Model: Pomelo	Date: 30-Apr-99	No.: RG033001a
---------------	-----------------	----------------

Subject: Detailed Self -diagnostics Error		Prepared by: H. Someya	
From: Technical Service Dept., GTS Division			
Classification:	<input checked="" type="checkbox"/> Troubleshooting	<input type="checkbox"/> Part information	<input type="checkbox"/> Action required
	<input type="checkbox"/> Mechanical	<input type="checkbox"/> Electrical	<input type="checkbox"/> Service manual revision
	<input type="checkbox"/> Paper path	<input type="checkbox"/> Transmit/receive	<input type="checkbox"/> Retrofit information
	<input type="checkbox"/> Other (      )

Model: Pomelo		Date: 15-Aug-99	No.: RG033003
Subject: Uneven or faint image / SC41		Prepared by: H. Someya	
From: Technical Service Dept., GTS Division			
Classification:	<input checked="" type="checkbox"/> Troubleshooting	<input type="checkbox"/> Part information	<input type="checkbox"/> Action required
	<input type="checkbox"/> Mechanical	<input type="checkbox"/> Electrical	<input type="checkbox"/> Service manual revision
	<input type="checkbox"/> Paper path	<input type="checkbox"/> Transmit/receive	<input type="checkbox"/> Retrofit informat

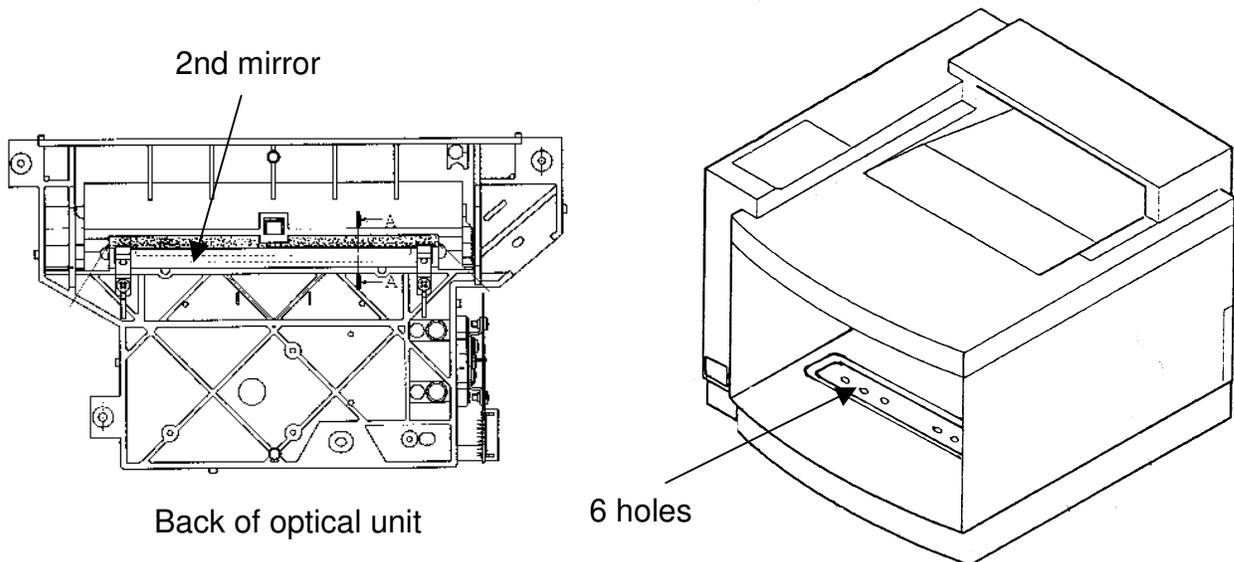
- Uneven or faint image
- SC41 appears.

Dust entering from the holes in the base adheres to the 2nd mirror over time.

1. Remove the optical unit and clean the 2nd mirror with an optical cloth.
2. Use tape to block the 6 holes in the base.
3. Reassemble the machine.

Polyester tape has been attached to block the 6 holes in the base (effective as of February production runs).

Diagram 1

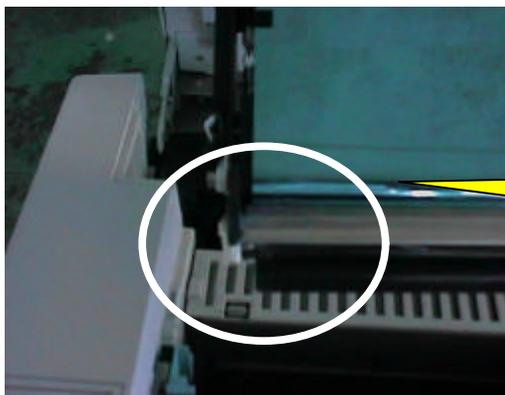
1. Remove the belt cartridge.
2. Measure the gap L between side plate and OPC belt as shown in diagram 1.
3. Do one of the following actions depending the length of gap L:

Gap L (mm)	Required action
0 – 3	Attach one spacer to the bearing on side A as shown in diagrams 2 & 3.
3 – 7	No action necessary
7 - 10	Attach one spacer on the bearing on side B as shown in diagrams 2 & 3.

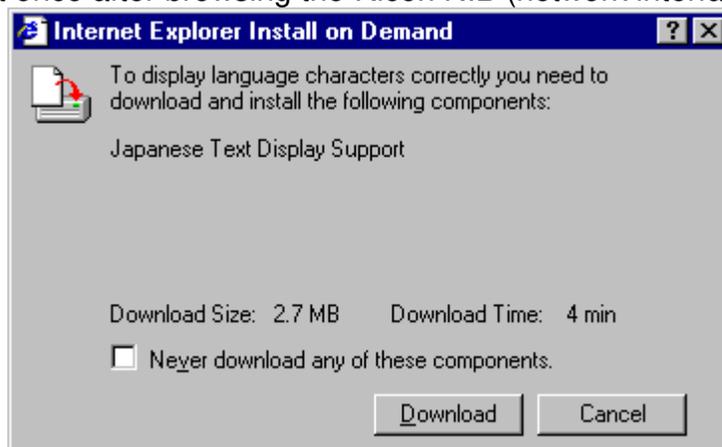
When you browse the Pomelo and FresaWIN printers with Microsoft Internet Explorer 5.x (IE 5.x), IE 5.x requires installing a Japanese font even if the HTML does not have a Japanese font.  
 i.e., if browsing [http://Printer IP Address/en/cgi-bin/sts\\_index.cgi](http://Printer IP Address/en/cgi-bin/sts_index.cgi), the following message appears:

Maybe the message is different because of a minor variation in the IE version or Windows OS. The above message appears when using IE 5.00.2920.0000 with Windows 2000. In this case, IE requires a Japanese font every time.

If the NIB version is 3.8.7 or earlier, please get the latest Ricoh NIB firmware and install the new one in the NIB.

Install a Japanese font in Windows. There are a few ways to install Japanese fonts.
